University of Alaska Gold Creek Spill Site Panel Review Report

Prepared for the Alaska Railroad Corporation

December 4, 2000

Figure 1
Geologic Cross Section Between the
ARRC Gold Creek Spill Site and Susitna River

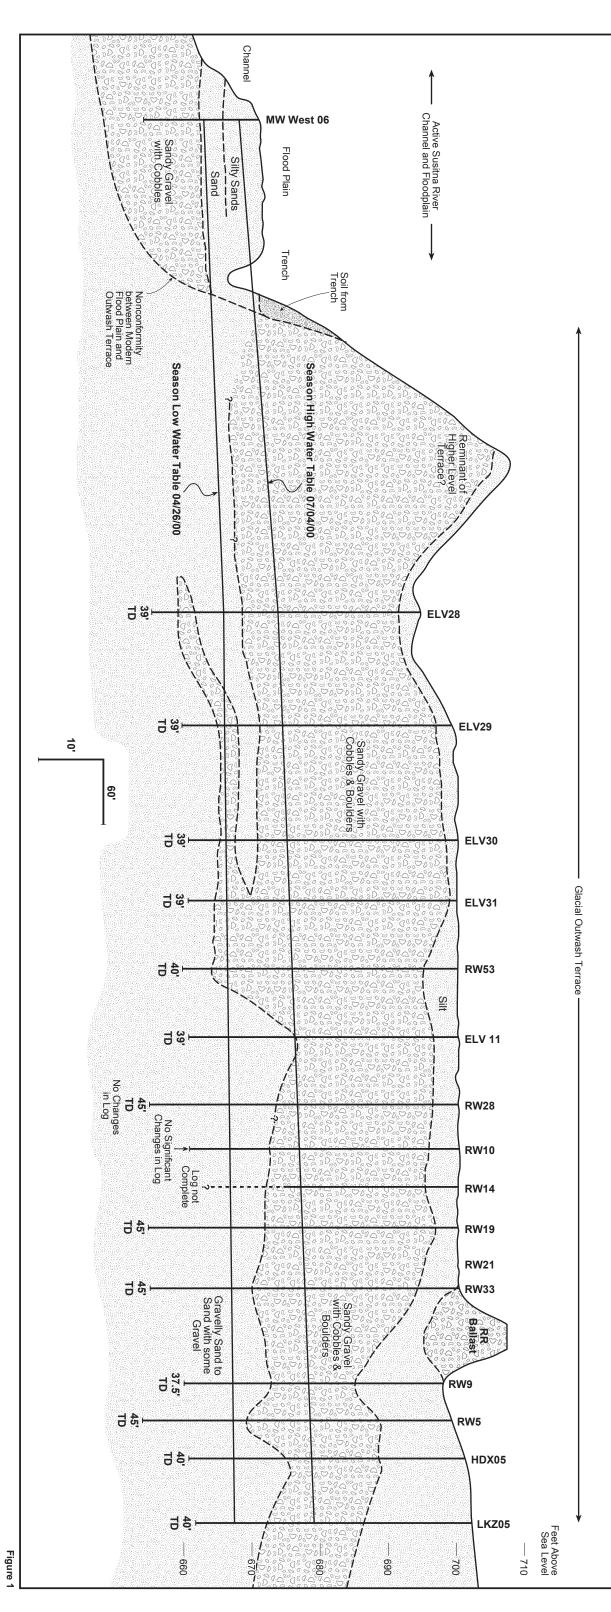
At the ground surface on the outwash terrace, most boring logs show a fine-grained soil described variously as a silt, fine sandy silt, or clayey silt. For simplicity, this surficial fine-grained soil is referred to as silt in this document. The silt reportedly is stratified, contains organics, is moist but not saturated, and is often oxidized to a red, brown, yellow or tan color. The silt varies in thickness from up to 16 feet on the east edge of the site (LKZ05) to 13 feet on the east side of the railroad tracks (RW9), to 6 feet on the west side of the tracks (RW33), and is only about 2 feet near the western edge of the outwash terrace (ELV 29). The silt is thought to be overbank floodplain sediments of the same age as the outwash terrace and/or alluvial fan sediments and colluvium from the Talkeetna Mountain slopes to the east. The silt likely increases in thickness to the east of the tracks

Most boring logs show a very coarse-grained soil underlying the silt. This material has been described variously as a gravel with cobbles and boulders, sandy gravel with cobbles and boulders, or just cobbles and boulders. In this report, for simplicity, this soil layer is described as a gravel. The most distinctive characteristic of this soil layer is the abundance of cobbles and boulders, which are described as comprising up to 40 or 50 percent of the soil volume. The presence of the cobbles and boulders indicates a very high-energy depositional environment, suggesting that the sands present in the soil are likely to be coarse sands and that silt and fine sand contents of the gravel layer are relatively low. The very coarse-grained texture of the soil indicates that the gravel layer likely has a very high hydraulic conductivity and retains relatively little fuel as pendular (i.e., fuel retained by capillary forces in the vadose zone) or insular (i.e., fuel retained by capillary forces in the saturated zone) residual saturation. The gravelly layer appears to extend to a depth of about 25 to 32 feet below grade. On the outwash terrace, this corresponds to an elevation of about 670 feet above sea level.

Most boring logs show the presence of a sand or gravelly sand layer underlying the gravel soil. For simplicity, this soil layer is described as a sand in this report. The sand grain size reportedly varies from a fine to coarse-textured sand. The layer contains some gravel and scattered cobbles, and limited blow count data indicate that the sand is moderately dense. Because most borings in the outwash terrace terminate at a depth of about 40 feet below ground surface (or at about the 660-foot elevation) in the sand layer, the thickness of the sand layer and the elevation of the bottom of the sand layer are not known.

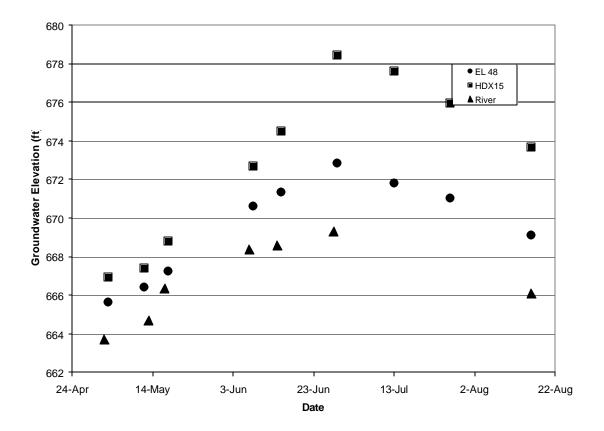
Figure 2a is a typical groundwater surface contour map for August 16, 2000. This map was created using groundwater elevations from 104 different monitoring wells located at the site. The contour map suggests that groundwater surface has a number of depressions and mounds near the tracks. Because maximum free product recovery rates using the skimming pumps are low (on the order of a few gallons per day), and the soils are highly transmissive, the operation of the recovery wells could not realistically produce the large drawdowns observed in this figure. Likewise, the operation of the soil vapor extraction system at the site could not account for the large mounds shown in Figure 2a (at most, the SVE system would create only a few inches of water table mounding which would be difficult to measure in an open well). Data entry errors, well casing survey errors and data transcription errors are the most likely explanation for the atypical groundwater surface contours shown in Figure 2a.

A somewhat different picture of the groundwater surface on August 16 is shown in Figure 2b. This figure was generated using 17 data points provided in the data table on the site map dated September 19, 2000 attached as Appendix A. None of the mounds and depressions shown in Figure 2a are present in Figure 2b. If only three data points are used, as was done in Appendix A, a somewhat different picture of the groundwater gradient and direction would again be anticipated. Eliminating data from some of the monitoring wells definitely "cleans up" the contour map and eliminates certain odd features, but it also reduces resolution and the ability to detect details in the groundwater gradients that could exist at the site.

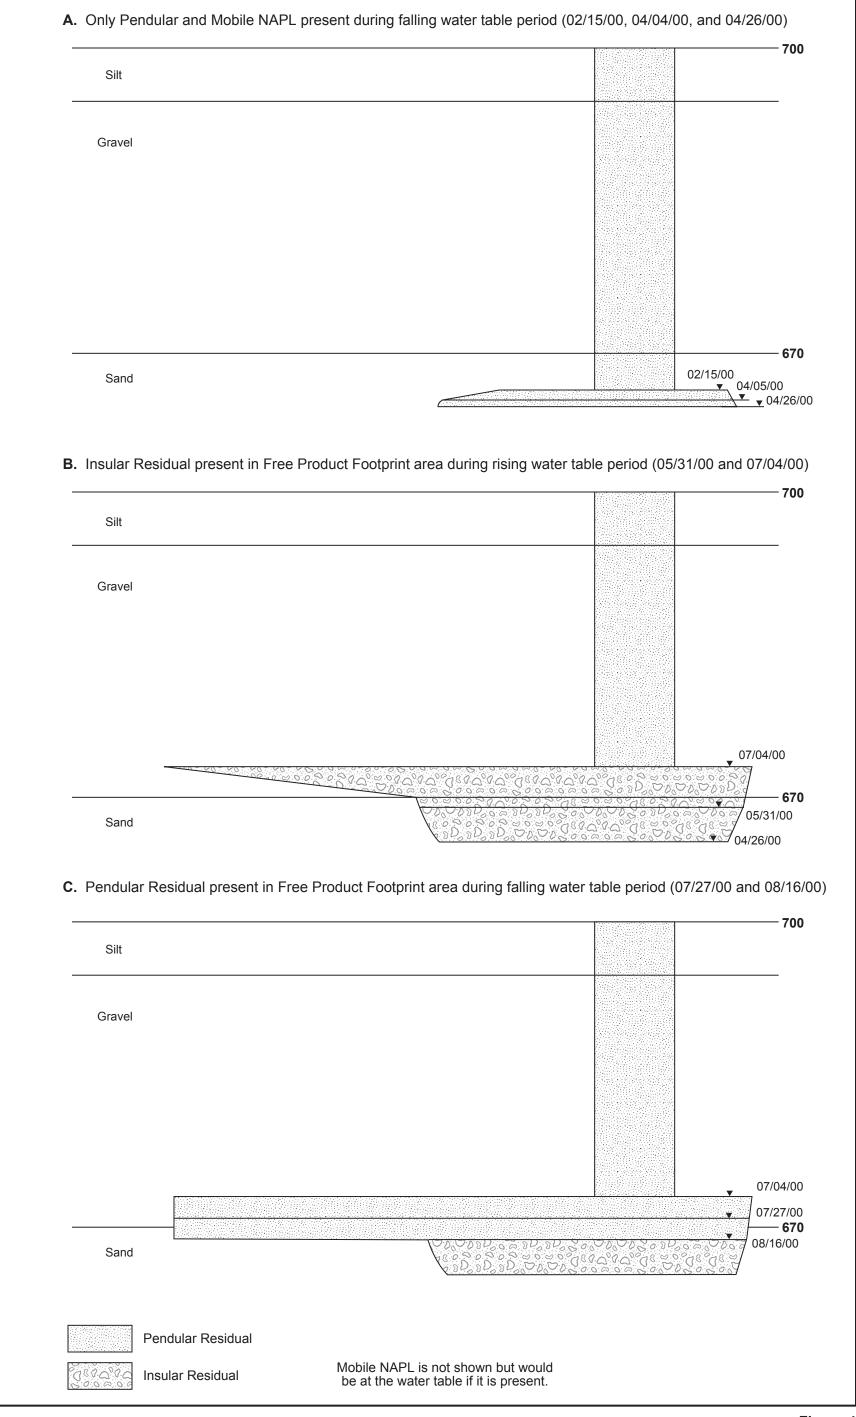
The calculation of residual LNAPL volume for the Gold Creek site utilizes the simplified cross section presented in Figure 4. The conceptual cross sections show the changing water table elevations and the associated changing areas of pendular and insular residual saturation. The volume of product potentially immobilized at the site was estimated using the following assumptions:

Results of the immobile residual calculation are shown in Table 4. The calculations indicate that as the water table fluctuates the volume of free product potentially immobilized increases. For example, in the February to late May time frame the potential residual product volumes increase from about 40,000 gallons to over 90,000 gallons. As the foot print area expanded in late June and early July the potential residual product volume could increase to over 180,000 gallons, a volume greater than the spill volume. The calculations suggest that given the reported water table fluctuation and free product foot print area the entire spill volume could be immobilized even when using very conservative (i.e. low) residual saturation values.
